**COUNTY OF SAN MATEO
PLANNING AND BUILDING DEPARTMENT**

SUBJECT: EXECUTIVE SUMMARY: Consideration of a Design Review and Coastal Development Permit to construct a new ~~2,763~~ 2,798 sq. ft. two-story single-family residence with attached ~~474~~ 464 sq. ft. garage on a 6,210 sq. ft. parcel and right-of-way improvements to allow for emergency vehicle access. The project involves 120 cubic yards of grading for site improvements and no trees have been proposed for removal.

County File Number: PLN 2019-00229 (Deac)

**COUNTY OF SAN MATEO
PLANNING AND BUILDING DEPARTMENT**

1 FRONT NORTH ELEVATION SCALE 1/4" = 1'-0"

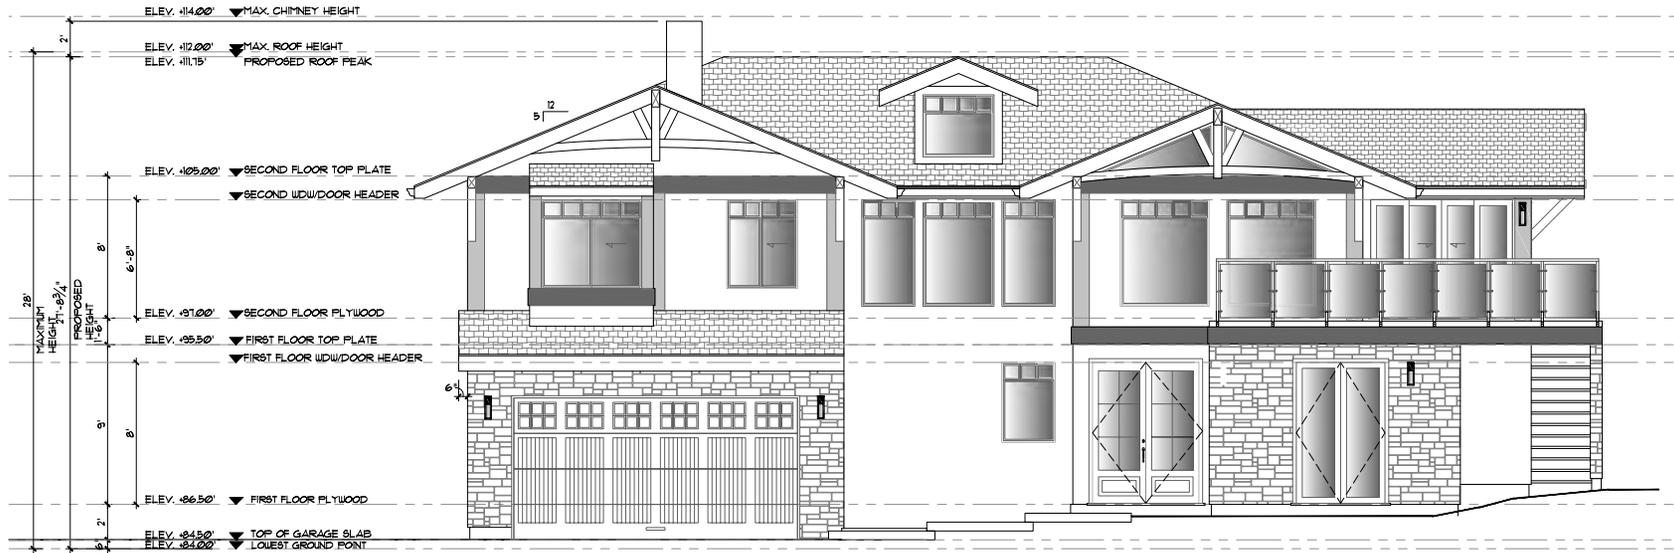
- j. Provide dark sky compliant exterior lights. Limited to one (1) light per exterior door, except at garage door on North elevation and living room door where two (2) lights will be permitted for both doors.

10. Provide dark sky compliant exterior lights. Limited to (1) light per exterior door, except at garage door on North elevation and Living Room door where (2) lights will be permitted for both doors.

2 LEFT SIDE EAST ELEVATION
SCALE 1/4" = 1'-0"

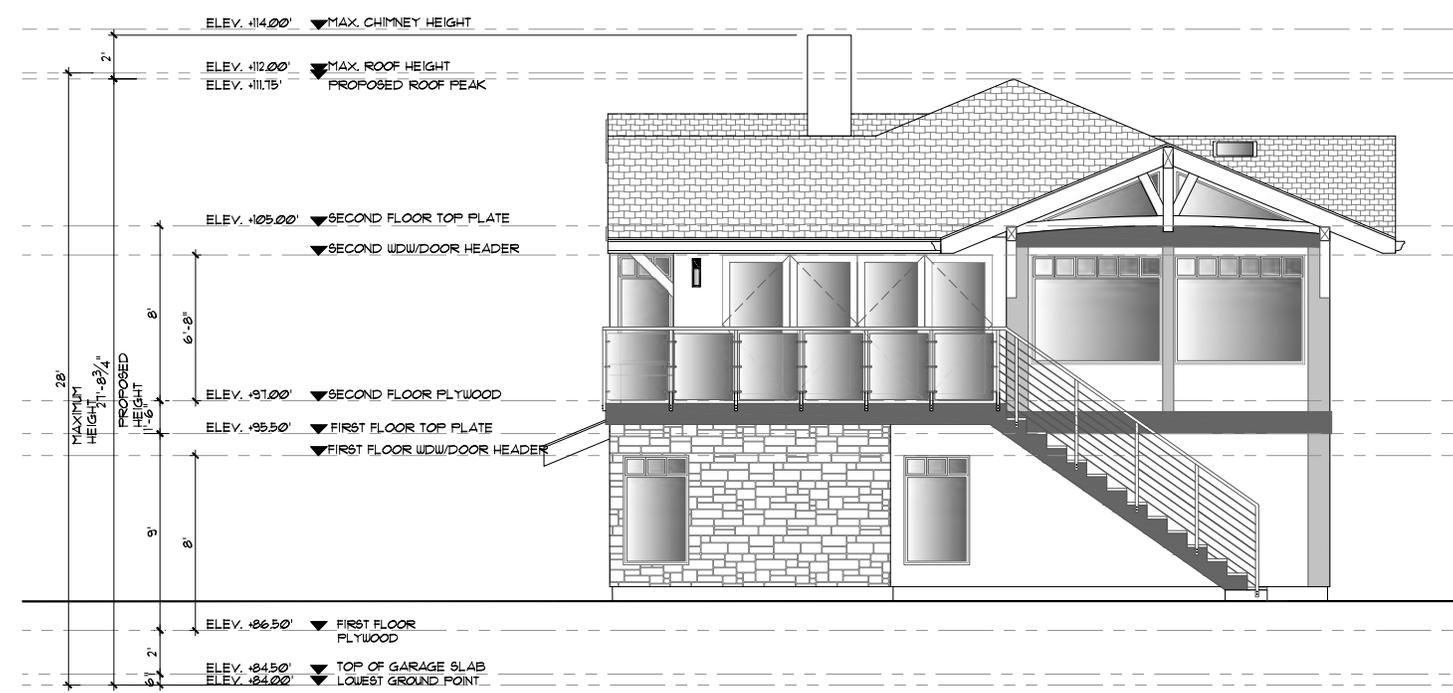
- i. East Elevation:
 - (1) Extend vertical trim elements from second floor down to wall of garage.
 - (2) Add single hinged door at rear of garage to position door between vertical trim elements, close to center of wall.

- (3) Add two (2) windows in garage. Align head with head height of added garage door. Position left window left-side jamb with left-side jamb of window, above. Position right window symmetrically in the space created by the corner vertical trim and added vertical trim extended from above.

9. East Elevation:
 - a. Extend vertical trim elements from second floor down to wall of garage.
 - b. Add single hinged door at rear of garage to position door between vertical trim elements, close to center of wall.

- c. Add (2) windows in garage. Align head with head height of added garage door. Position left window left-side jamb with left-side jamb of window, above. Position right window symmetrically in the space created by the corner vertical trim and added vertical trim extended from above.
